ADDENDUM NO. 1

INTERSTATE-5 FREEWAY
PARKING STRUCTURE

I-5 Sacramento
Parking Structure

JOB I-5 FREEWAY PARKING
 STRUCTURE - SACRAMENTO
 BY LS
 CKD.
 DATE 2-6-81
 JOB NO. 79029
 SHT. 7 OF
 CONRAD ASSOCIATES
 RA-1

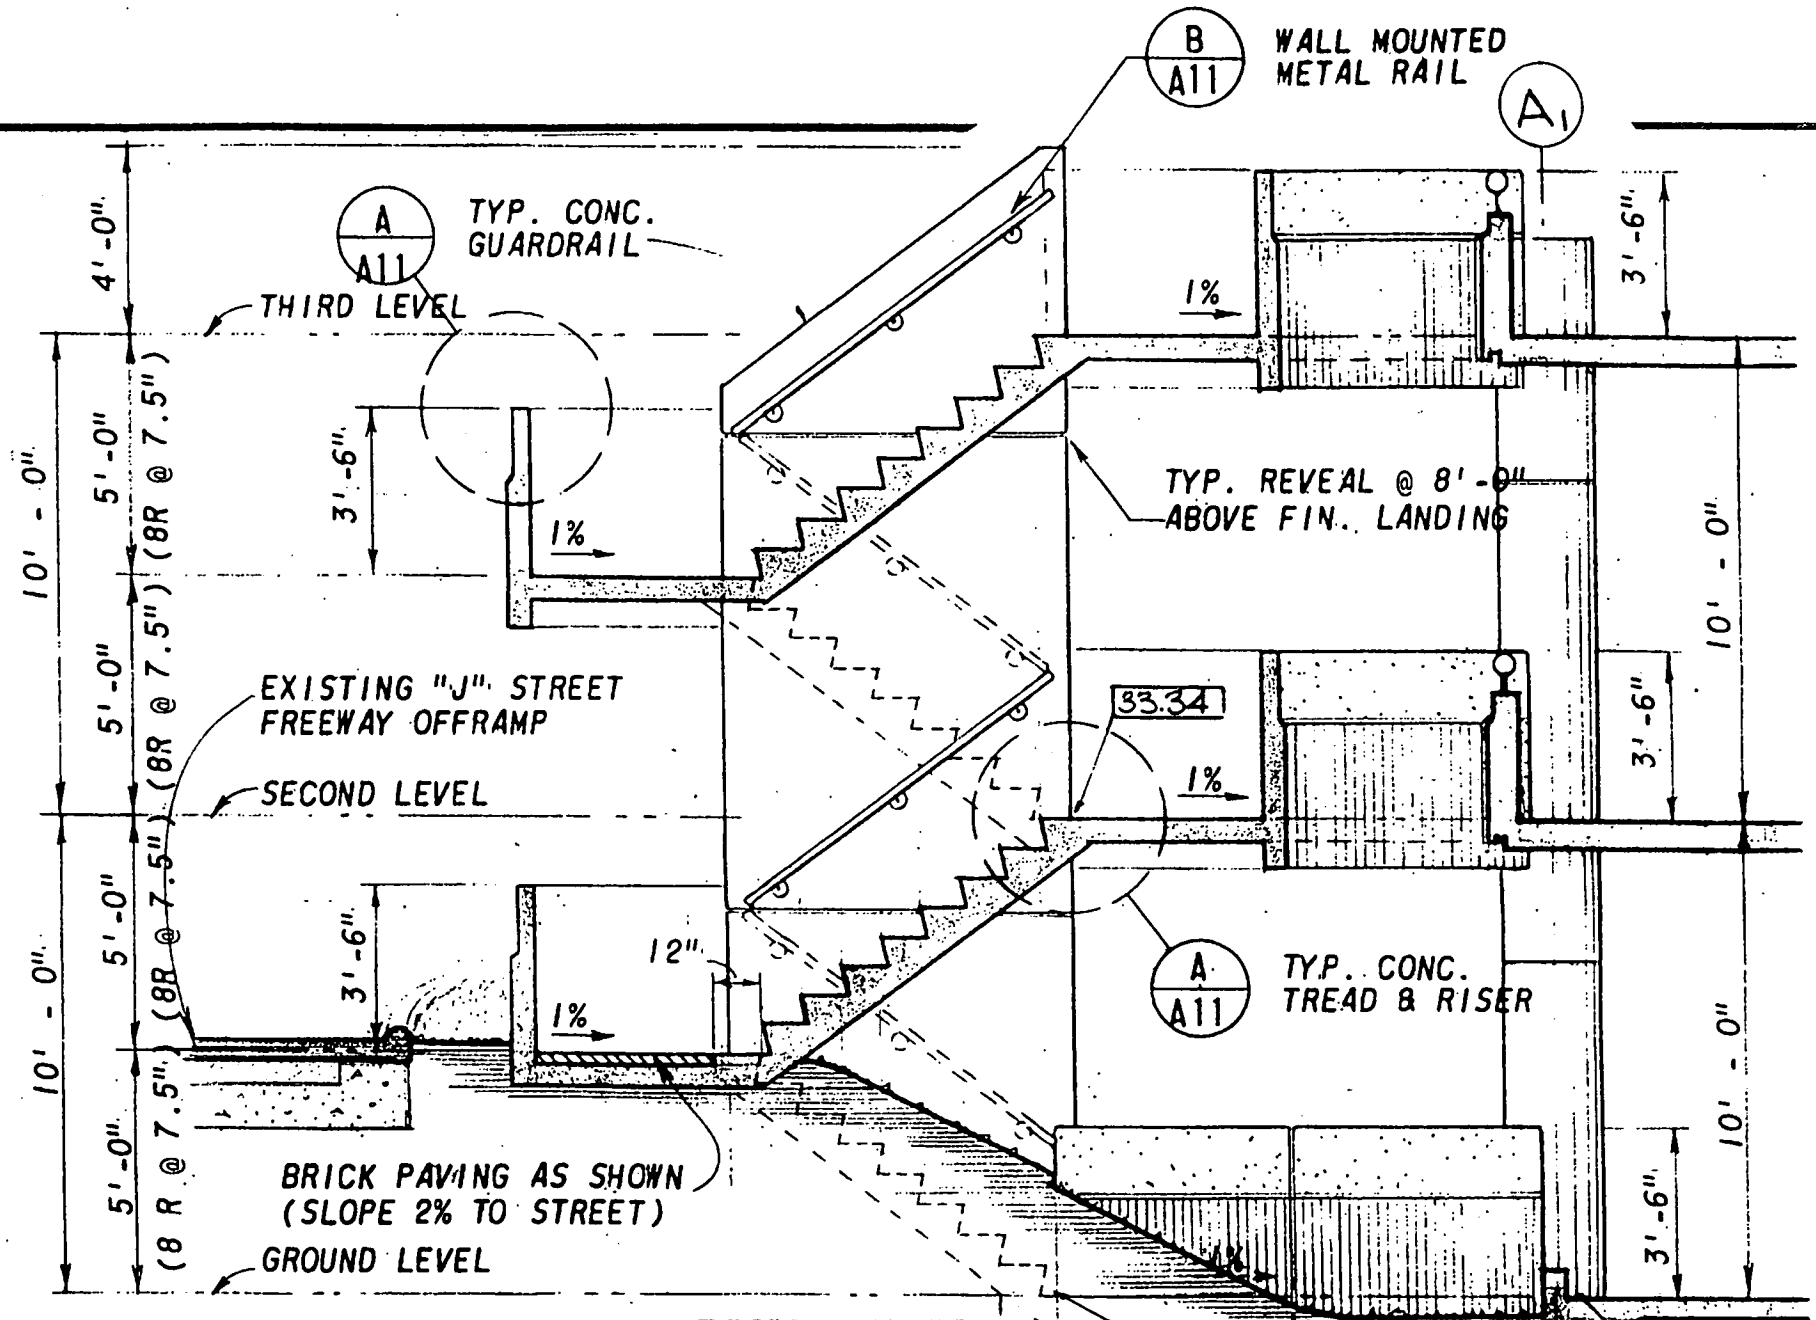
3. Drawings - Sheet A-11 Detail 3/A-11
Revise top of center wall of stair #3 to slope down to South.
See sketch RA-1, page of this addendum.
4. Drawings - Sheet A-11 Detail 7/A-11
Revise appearance of chain link guard rail - See sketch RA-2
page of this addendum.

THIS DETAIL SUPERCEDES
 DETAIL 3/A11 ON DWG. A11

STAIR NO. 3 - SECTION

CONRAD ASSOCIATES
RA-2

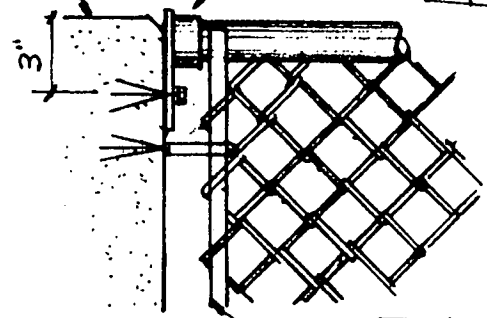
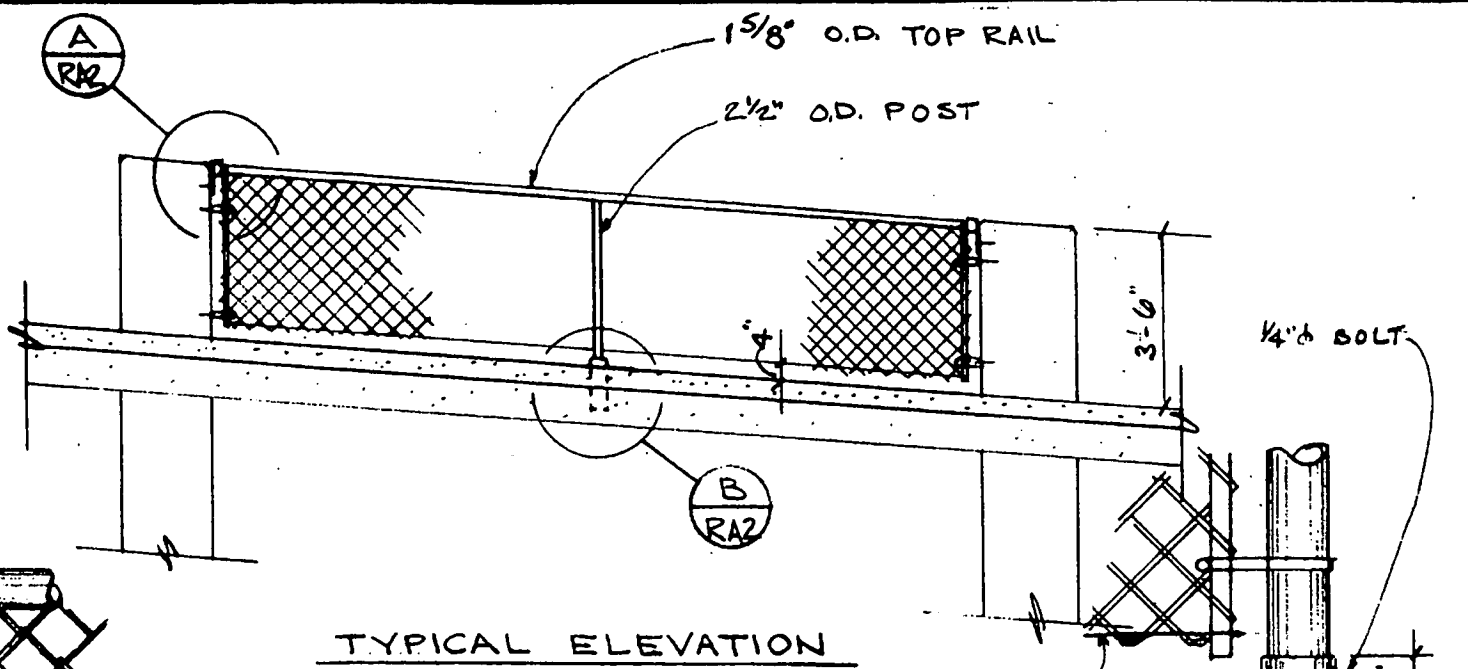
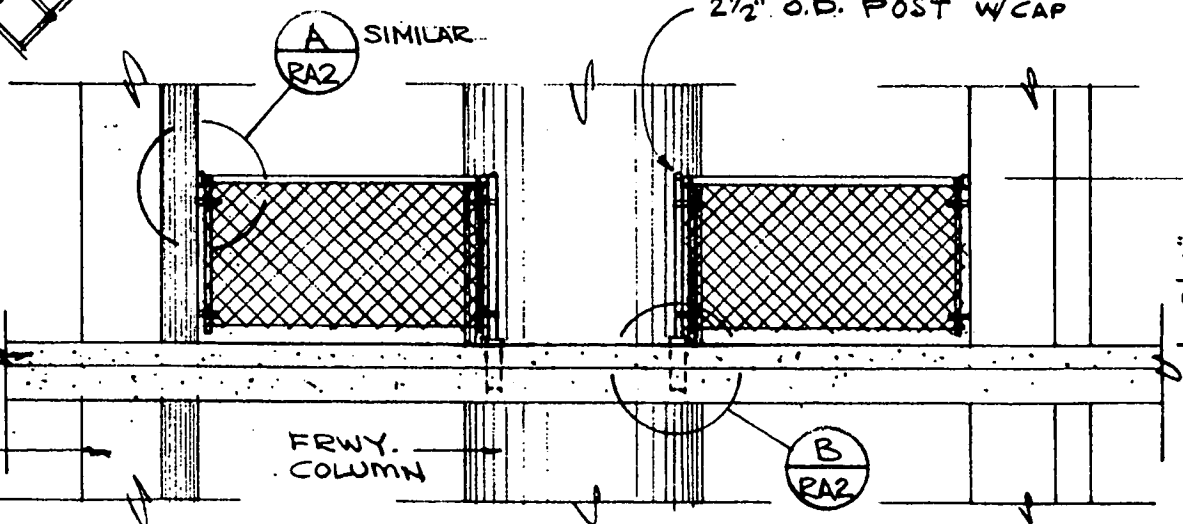
THIS DETAIL SUPERCEDES
DETAIL 7/ALL ON DWG. ALL
